**51 CHARDON DRIVEWAY
TUNNEY'S PASTURE
OCCUPATIONAL HEALTH UNIT (OHU)
MODERNIZATION
SPRINKLER AND LIGHTING SURVEY**

MECHANICAL AND ELECTRICAL REPORT

**GWA 2014-468
September 26, 2014**

MECHANICAL
EXISTING SPRINKLER
LAYOUT

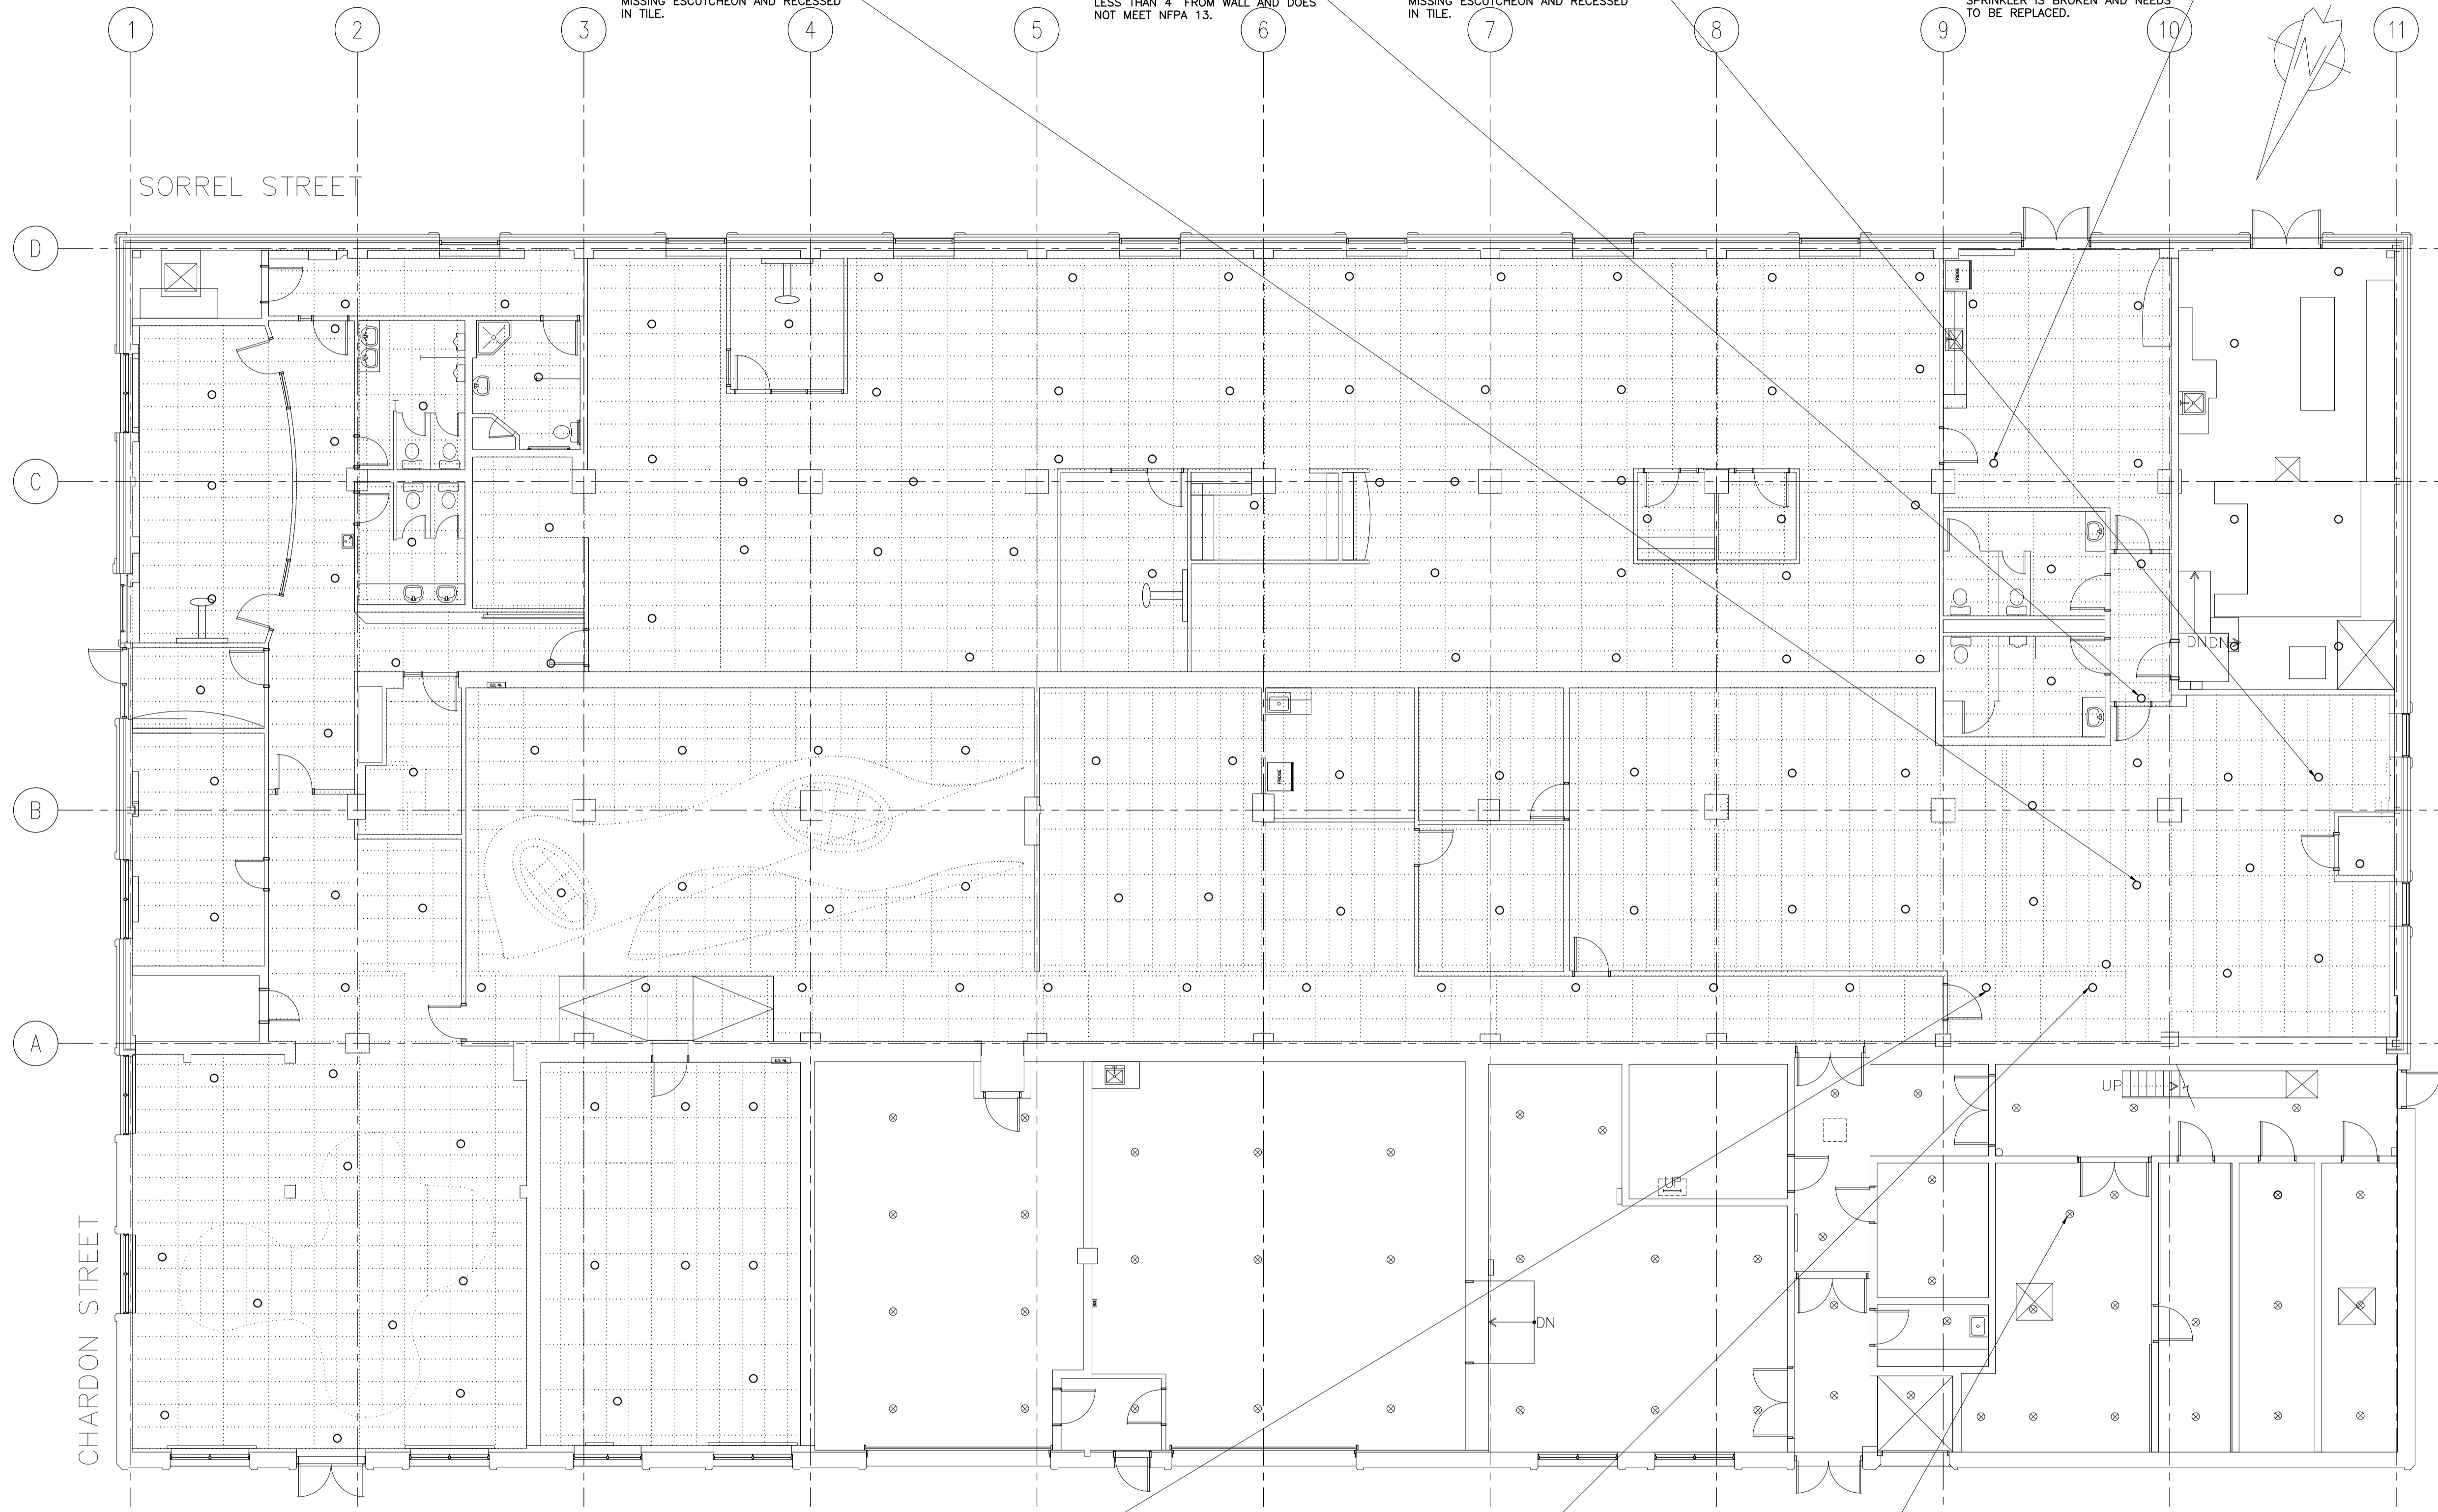
A single sprinkler zone is sufficient for this building as it is one storey and less than the maximum floor area of 52,000 sq.ft. per zone. In general the sprinklers layout is acceptable for a light hazard occupancy with some minor deficiencies that must be corrected. Sprinklers will need to be removed, repaired or replaced as per noted deficiencies. Refer to Figure 1 (Drawing M1) for noted deficiencies.

3 MISSING ESCUTCHEON AND RECESSED IN TILE.

6 LESS THAN 4" FROM WALL AND DOES NOT MEET NFPA 13.

7 MISSING ESCUTCHEON AND RECESSED IN TILE.

10 SPRINKLER IS BROKEN AND NEEDS TO BE REPLACED.

OLD STYLE SPRINKLER SHOULD BE REPLACED TO MATCH NEWER SPRINKLERS.

SPRINKLERS ARE LESS THAN 6 FEET APART AND DO NOT MEET NFPA 13 REQUIREMENTS.

EXISTING HEAD NO LONGER REQUIRED. SHOULD BE REMOVED TO PREVENT ACCIDENTAL DISCHARGE.

**FIGURE 2: ELECTRICAL
EXISTING LIGHTING
LAYOUT**

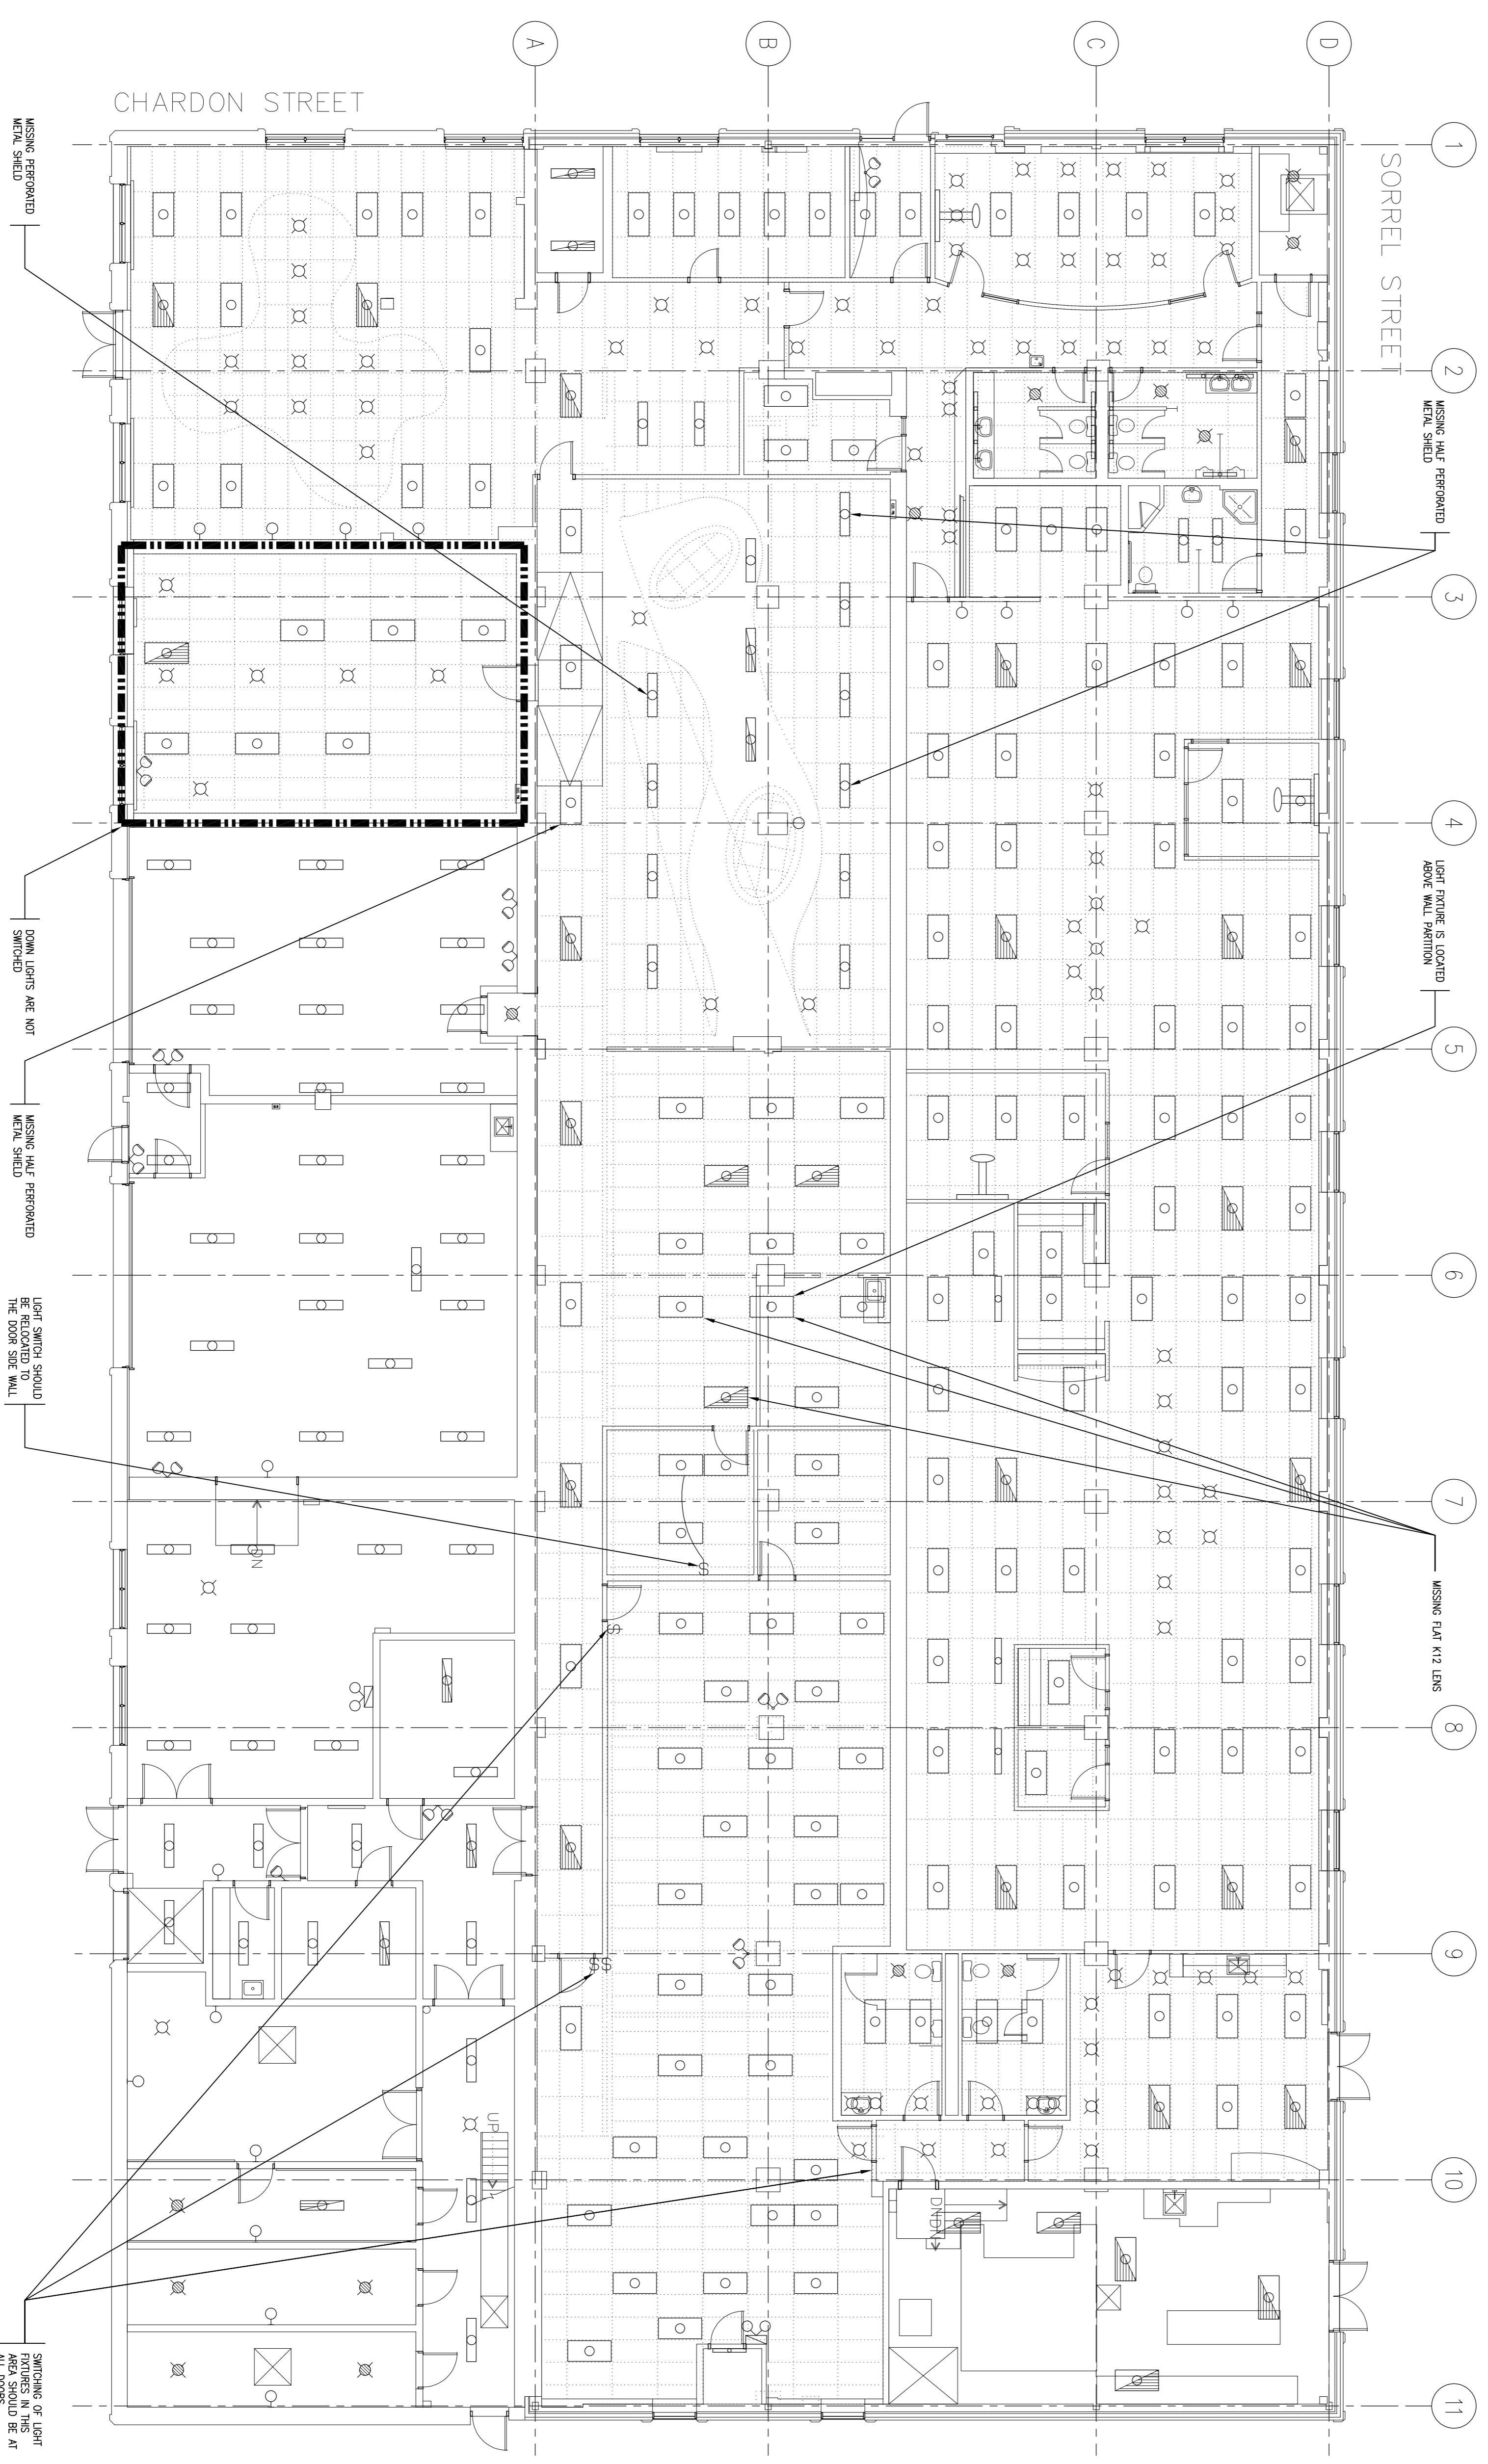
Overall, the lighting system appears to be functioning adequately for its intended purpose, which is to provide a minimum ambient lighting level, which is supplemented by task lighting at individual workstations. We recommend the following minor deficiencies be rectified: Replace missing 2'x4' and 1'x4' perforated metal shields, and flat K12 lens to reduce unwanted glare from lamps. Disconnect and remove existing 2'x4' light fixture located above wall partition. Relocate/add light switching to make turning on/off of lighting more convenient. Refer to drawing Figure 2 (Drawing E1).
